T10/07-046r3

**To** INCITS T10 Committee  
**From** Michael Banther, HP  
**Subject** SSC-3 Requested Recovery log page

**Date**  
18 September 2007

Figure 8 – UML example of SCSI target device and physical device

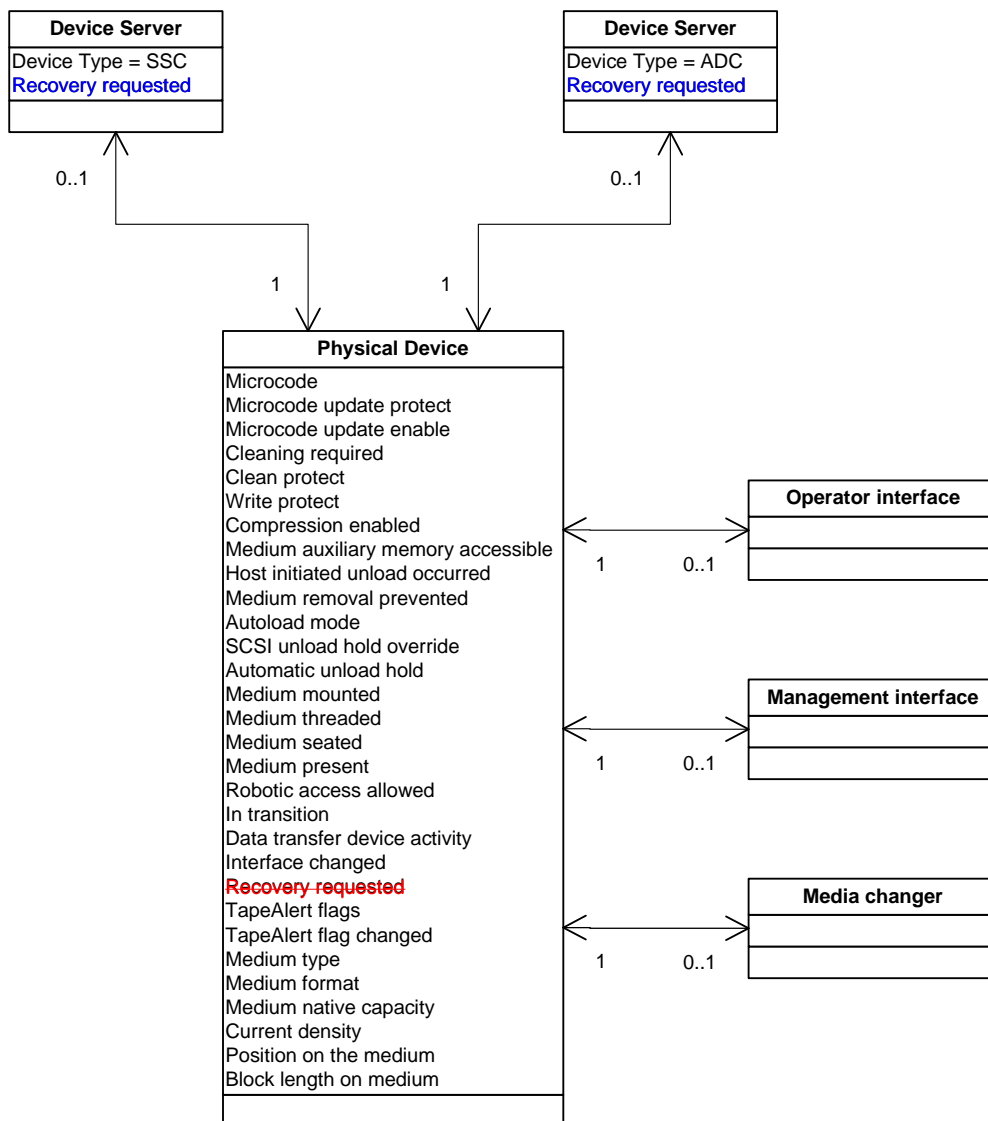
These entities perform operations that change various attributes of the physical device. These attributes affect the operations on a volume. Figure 8 shows in UML notation an example of the entities in a SCSI target device, and shows the attributes which comprise the physical device.
